Date Issued :	March 11, 2024	PCN Number :	515041
Reason for Change :	Change Supplier		
Description of Change :	This notification is to inform you about Modjack products' current light pipe mold is going end of life, Molex ChengDu will replace it with new copy mold from a different supplier.		
Assessment of Change :	Dimension analysis		
Planned Implementation Date :	September 30, 2024		
Customer Sample Availability Date:	August 01, 2024		
Last date to request Samples by Customer :	August 01, 2024		
Please note if Samples are not requested as per Customer Samples Request date, it may take additional 4-6 weeks to arrange Samples.			
Traceability Code Markings / Date :	Date code

■ Photo of affected product

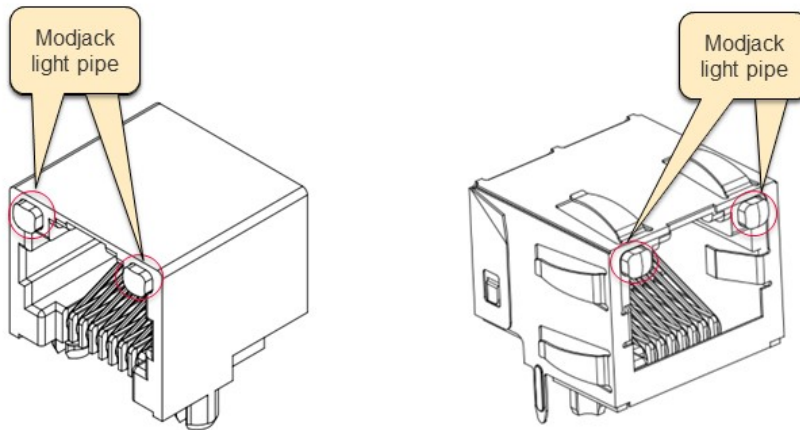
- Modjack products' current light pipe mold is going end of life, Molex CD will replace it with new copy mold from a different supplier. It's a duplicate mold with no change in design/build.
 - Before : Existing light pipe mold from current supplier
 - After : New light pipe copy mold from a different supplier (copy mold)
- **Product Impact**
 - Material grade does not change, "no impact to fit, form, function".
- **Part Number Impact** - see attached impacted parts list
- **Qualification report will be available upon request after 2024/08/01. Request for report must be raised by 2024/08/01. Submissions will not occur without request.**
 - If report requested, disposition response required within 5 days of report submit date or it will be considered approved.
 - If no report requested by 2024/08/01, the PCN will be considered approved.
